**SUBJECT: Plan Change 58: Technical Memorandum – Transportation**

## TECHNICAL MEMORANDUM WITH REGARD TO PLAN CHANGE 58

## **PROPOSED PRIVATE PLAN CHANGE 58 AVENUE ROAD INDUSTRIAL: REVIEW OF FURTHER INFORMATION**

Figure 1 Extract from drawing set for Consent 101.2021.12429

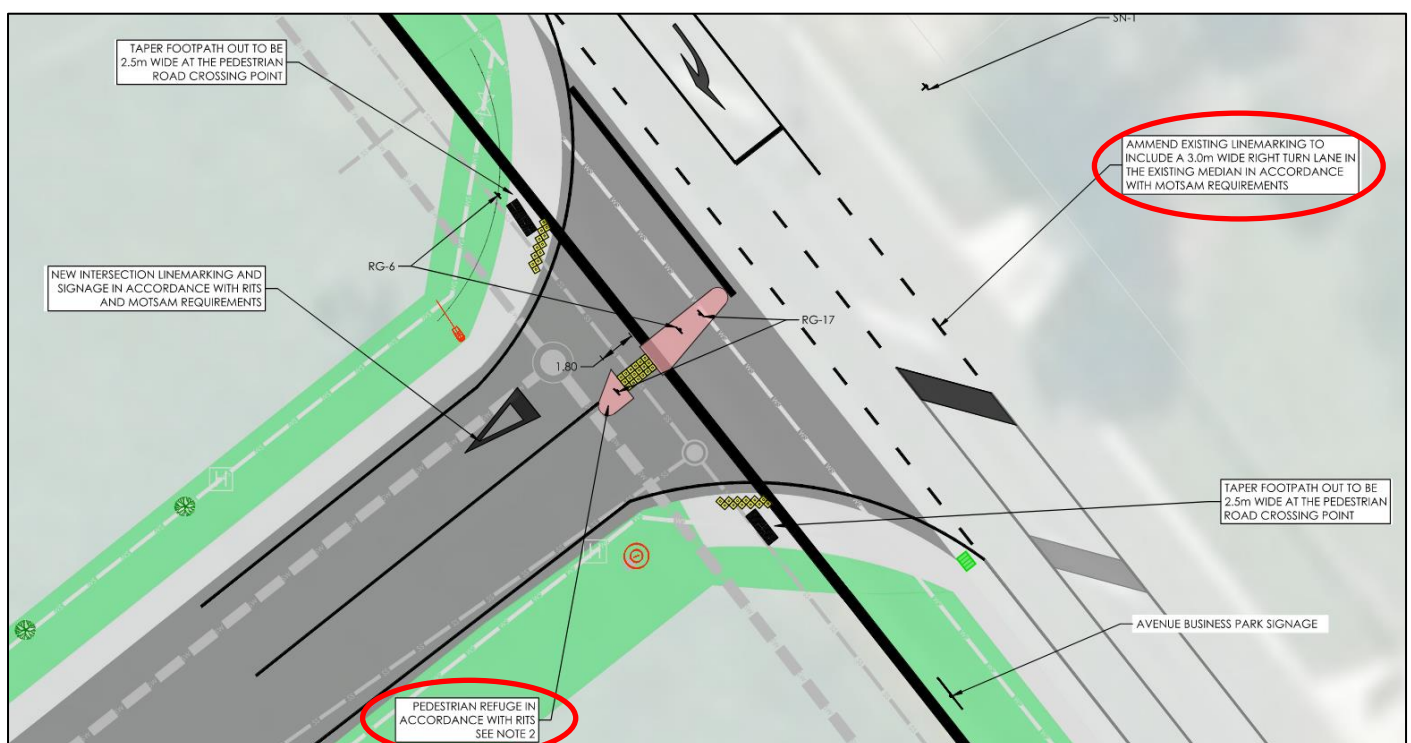
I raised concerns with the intersection layout drawings, including:

- = Heavy vehicle tracking encroaching into oncoming lanes, right turn bay and flush median.
- = Lack of detail on the drawings, including survey information, lane widths, farside kerbs and tie ins at the extents, meaning that it was not clear how the proposed 3m wide right turn bay would fit within the existing carriageway or required extent of pavement widening and new kerb lines.
- = Issues with the drawing scale not matching the dimensions annotated on the drawings.

I recommend that a 3m wide right turn bay is provided on Avenue Road North. This will require widening of the carriageway to provide a cross section that adequately provides for the turning movements and meets arterial road standards.

Figure 4 Extract from RITS D3.6.4 Island kerb details

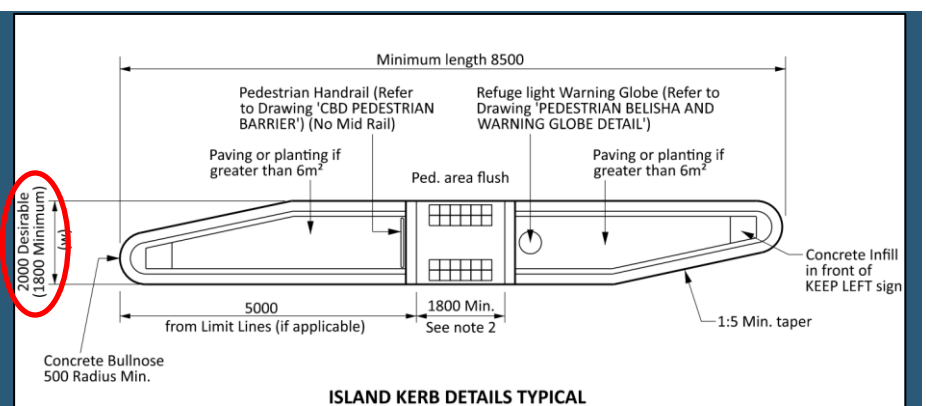
The constructed pedestrian island is 1.6m wide. This does not meet the RITS standards<sup>1</sup> which are a desirable width of 2m or minimum width of 1.8m. There is a potential safety effects associated with a narrow pedestrian island. Pedestrians pushing prams / strollers, or bicycles may not be able to stop in the refuge area without protruding into the vehicle lanes.

The consequence is an increased risk of conflict between pedestrians/cyclists and vehicles. The refuge should be widened to meet the standards specified in RITS (shown above).

Figure 6 Plan Change 58: Development Area Plan and Local Road Network

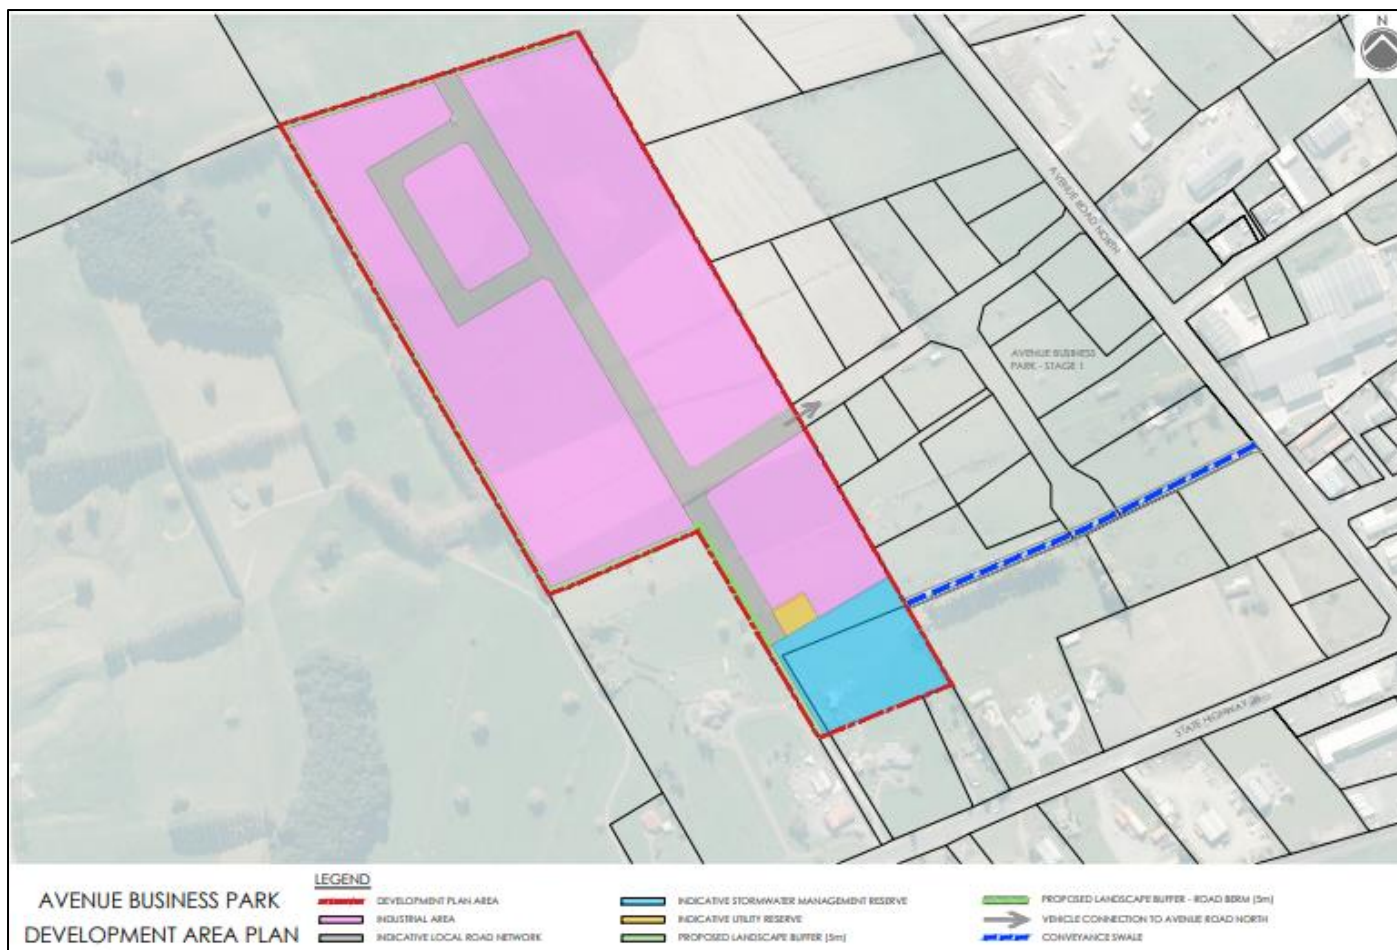
The Applicant proposes cross sections to a local road standard with a minimum 20m wide road reserve width, 10m wide carriageway and 1.5m footpath on one side. The proposed cross sections do not allow for drainage features e.g. swales or raingardens and do not specifically accommodate cyclists. I prefer that typical cross-sections are provided in the District Plan provisions to avoid doubt and to ensure appropriate footpath and shared path widths are provided at the time of subdivision.

It would be desirable to provide for parking on both sides, however the carriageway would need to be around 11m to accommodate parking on both sides. So long as cyclists are accommodated by a shared path separate to the carriageway, I consider a 10m carriageway adequate for a local road to accommodate two traffic lanes (each 3.5-4m wide) and parking on one side.

Figure 7 Preferred cross-section for north-south road corridor

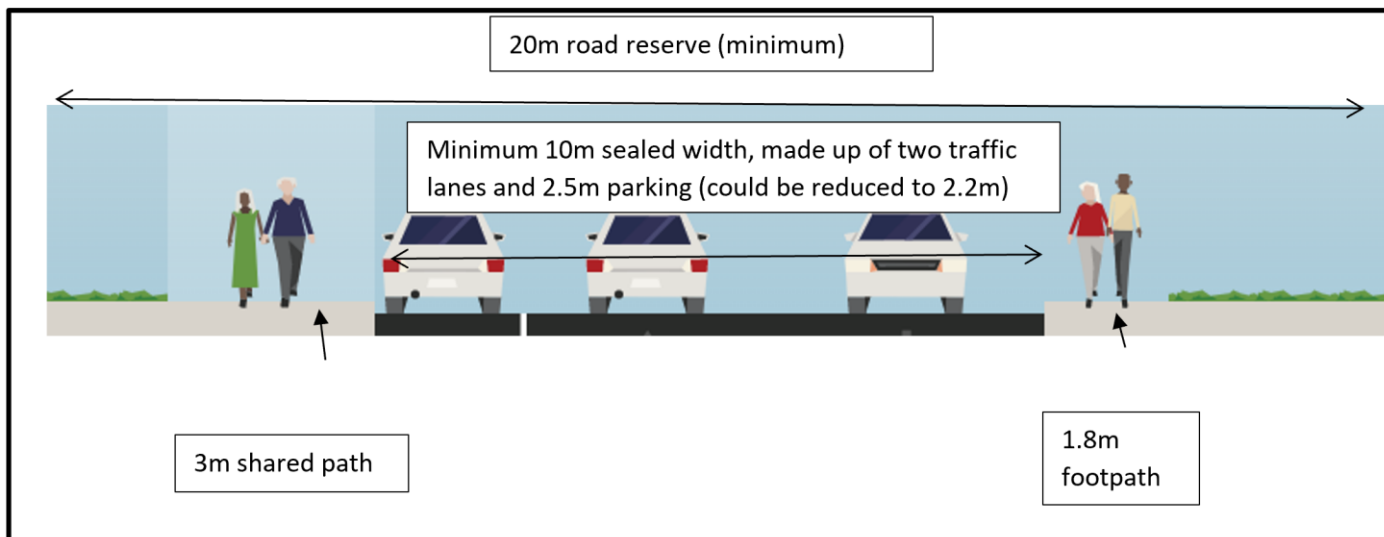
I recommend that the planning provisions include the cross section shown below as a requirement for the north-south corridor within the plan change area. The east-west corridor is discussed in more detail at Section 4.3.

Figure 9 New east-west road cross-section, extract from approved roading plans

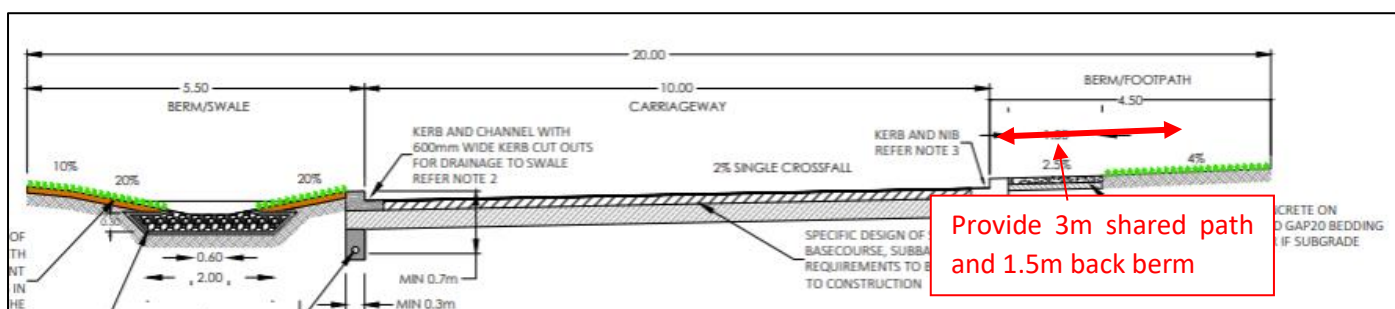
I recommend that the existing footpath is widened to be a 3m wide shared path, for use by both pedestrians, cyclists and micro-mobility users. This will provide a safe way for pedestrians and cyclists to access the PC58 area, minimising potential conflict with vehicles.

There is sufficient berm width to widen the path. However, I note there is some street lighting that may be affected.

This east-west road corridor will be extended in to the PC58 area. It would be appropriate for the east-west road extension cross section to match the recently constructed road, with the addition of the 3m shared path along the northern berm as annotated on the cross section in Figure 9.

Table 2 Planning provisions and suggestions

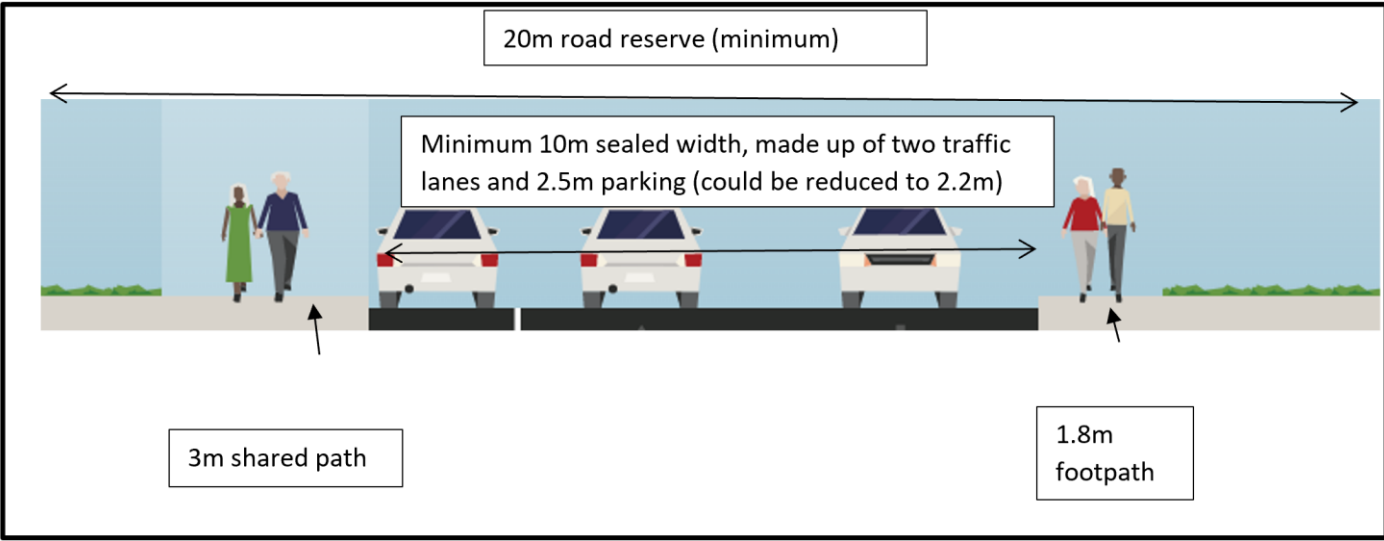
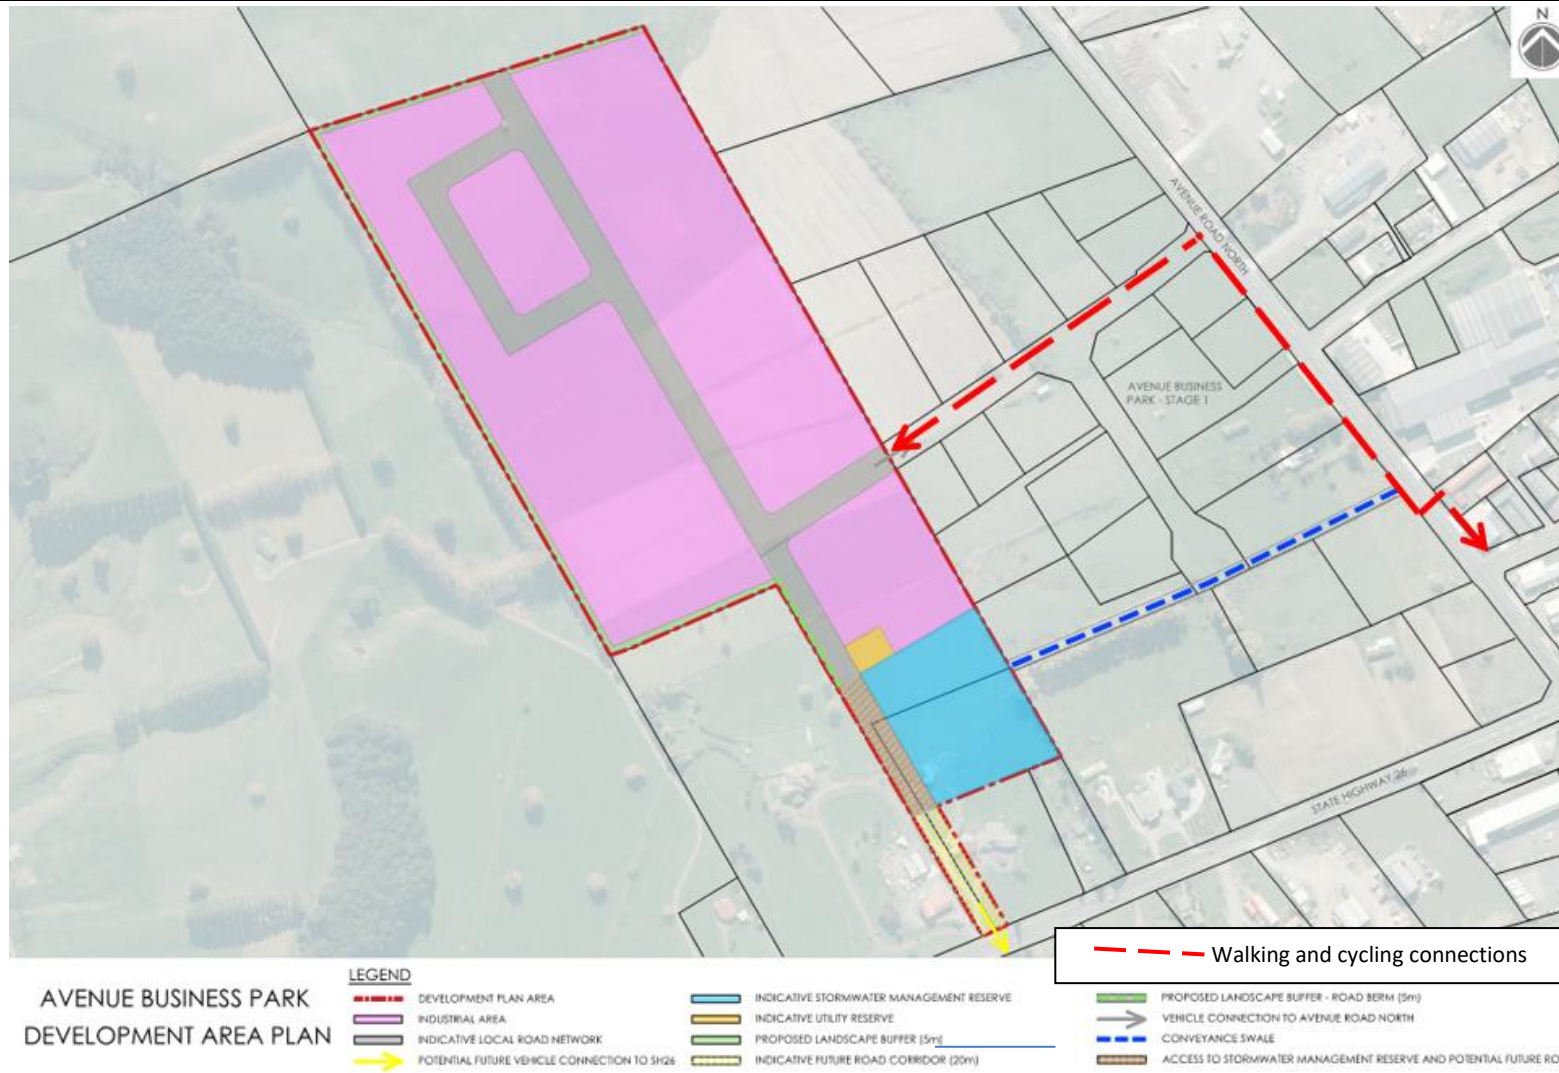
Proposed Provision	Comment
<p>9.6.1 Transportation Works Subdivision and development within the Avenue Business Park Development area (ADAP) shall provide:</p>	
<p>(a) A public road connection to Avenue Road North, <u>and improvements to the intersection with Avenue Road North</u>, as indicatively shown on the ADAP. Detailed design drawings of the intersection upgrade should be subject to detailed design approval by MPDC and include: -Provision of a 3m wide right turn bay, 3.5m lanes and 1.5m shoulders on Avenue Road North, -Provision of a 2m wide pedestrian refuge in accordance with RITS D3.6.4 on the new road, and -Provision of vehicle swept paths to confirm the layout is adequate to accommodate heavy vehicles.</p>	<p>Additional specifications to ensure the intersection upgrade adequately provides for turning and for pedestrians.</p>
<p>(b) A north-south aligned road through the site extending to the northern and southern boundaries and adjoining the boundary of Lot 1 DPS 64677, as indicatively shown on the ADAP;</p>	<p>Provision is adequate.</p>

Proposed Provision	Comment
<p><u>The road reserve width should provide for stormwater provision. Swales may need additional berm space.</u></p>	
<p><del>(d) Any existing pavement for public roads between the ADAP and Avenue Road North shall be assessed to ensure it is adequate for the proposed development.</del></p>	<p>I recommend this clause is standalone- refer 9.6.X below.</p>
<p><u>(d) The east-west road is to be constructed to match the cross section of the existing Road 1 within the Avenue Business Park Subdivision with a minimum 20m wide road reserve width, a minimum of 10m wide carriageway made up of two traffic lanes and parking on one side and a 3m wide shared path on the northern side. The existing footpath along the northern side of the existing Road 1 within the Avenue Business Park Subdivision is to be upgraded and widened to provide a continuous 3m wide shared path between Avenue Road North and the PC58 area.</u></p>	<p>New clause.</p>

<p><u>(e) The loop road is to be constructed to local road standard with a minimum 20m wide road reserve width, 10m wide carriageway and 1.8m wide footpath on one side.</u></p>	<p>New clause.</p>
<p><u>(e)-(f) No vehicle access shall be provided directly from the ADAP to State Highway 26.</u></p>	<p>Provision is adequate.</p>
<p>9.6.2 Walking and Cycling  <u>(a) Subdivision and development within the ADAP shall provide a continuous footpath connection between the ADAP and the existing footpath network on Anderson Street including a pedestrian crossing facility on Avenue Road North. The pedestrian crossing facility shall be subject to detailed design approval by MPDC.</u>  <del>access for pedestrians and cyclists to Avenue Road North via public roads. The requirement for pedestrian crossing places (such as a refuge) on Avenue Road North which are connected to public footpaths shall be investigated and provided if required and feasible.</del>            Opportunities for access to State Highway 26 shall only be required to be considered as part of subdivision and development within the ADAP if the posted speed limit on State Highway 26 west of Avenue Road North intersection has been reduced to 50 km/h by Waka Kotahi or if a public footpath has been provided by Waka Kotahi or Council along the northern side of State Highway 26 to reduce the need for pedestrians and cyclists to cross State Highway 26.</p>	<p>Add the walking and cycling connections between the ADAP and Anderson Road to the Area Development Plan</p>

**Figure 4: Recommended Collector Road Cross-Section**

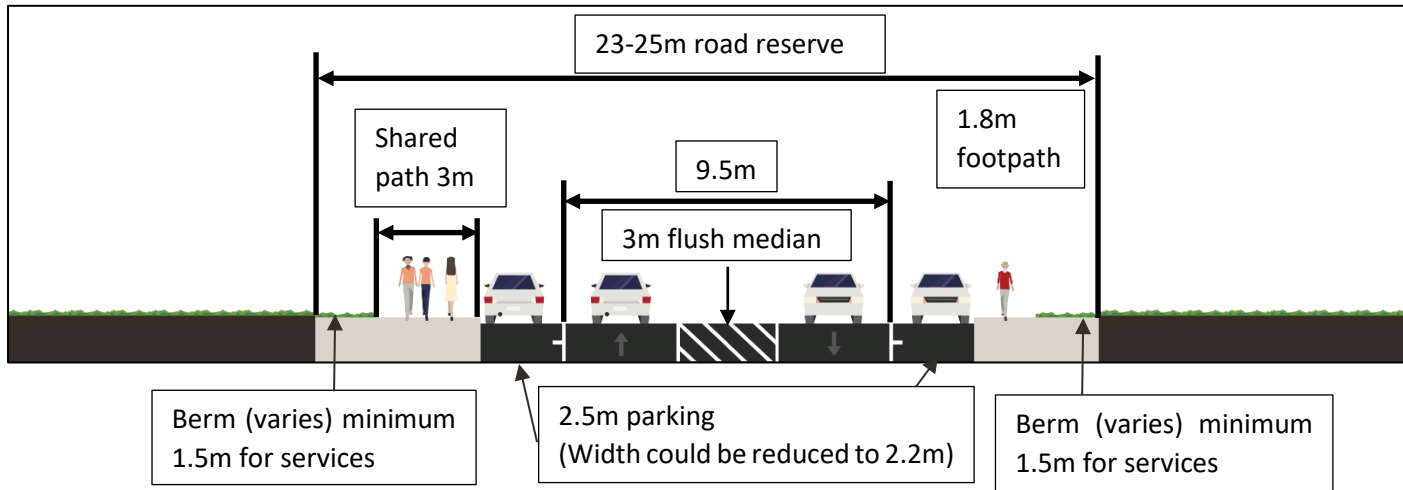
Our desired cross-section is shown in the figure below including two traffic lanes and a marked flush median to facilitate property access and heavy vehicle turning paths. Facilities for pedestrians are provided on both sides, including a desirable shared path on one side to also facilitate cyclist movements. To accommodate the desirable cross-section a minimum 23m wide road reserve should be protected. Protecting a corridor width of 25m would also accommodate the 5.5m wide berm/swale treatment proposed in the Figure 14 of the S92 further information response.

**Figure 5: Recommended Local Road Cross-Section**

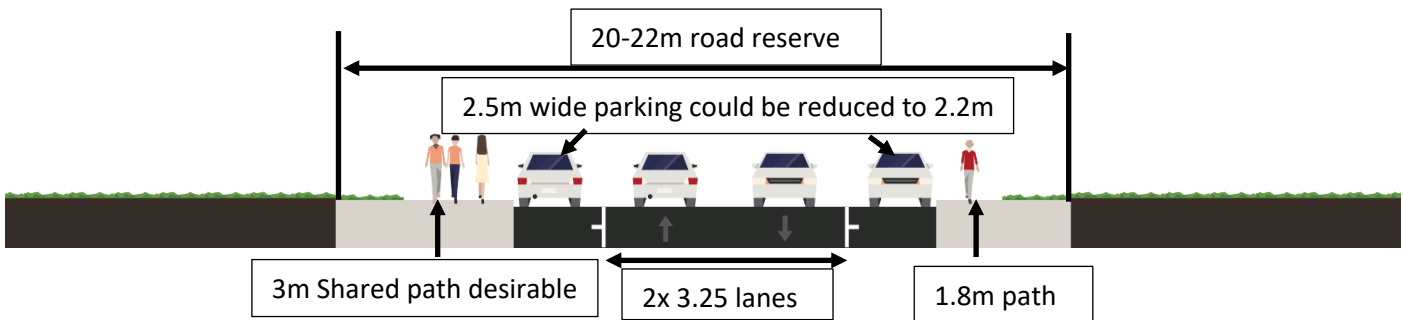
We recommend that the PC58 is updated to ensure that the local roads are formed so that they are appropriate for the form and function of the road. The local road cross-section is similar to the collector road but does not include a flush median. The shared path is desirable on the local road but could be converted to a 1.8m path with cyclists in the lane.

**Figure 6: Potential access to the west and SH26**

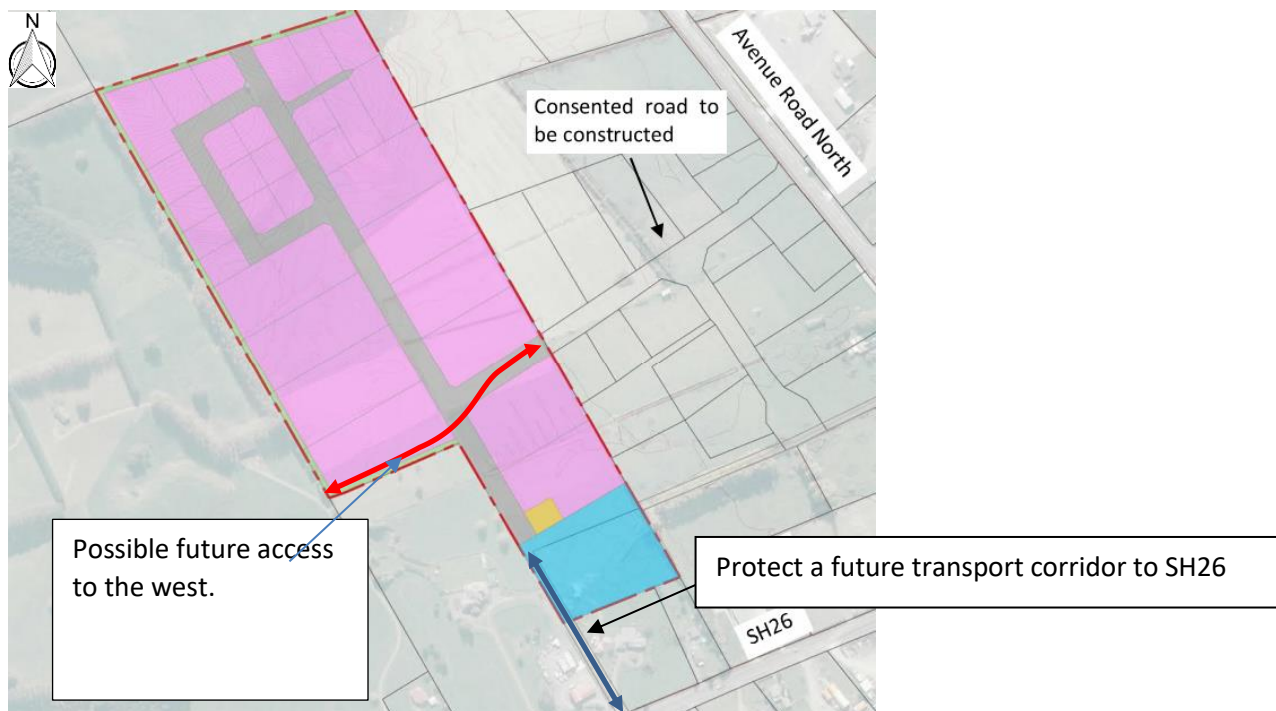
We consider that access to the west and to SH26 should not be precluded by the PC58. It would be desirable for the PC58 to protect a future connection to the west as well as to SH26. We recommend that a corridor is protected to SH26 so that future access to SH26 is not precluded. The corridor width should be sufficient to accommodate the collector road cross-section.

Should the area to the west of PC 58 be developed in the future, it would be desirable for access through the PC58 area.
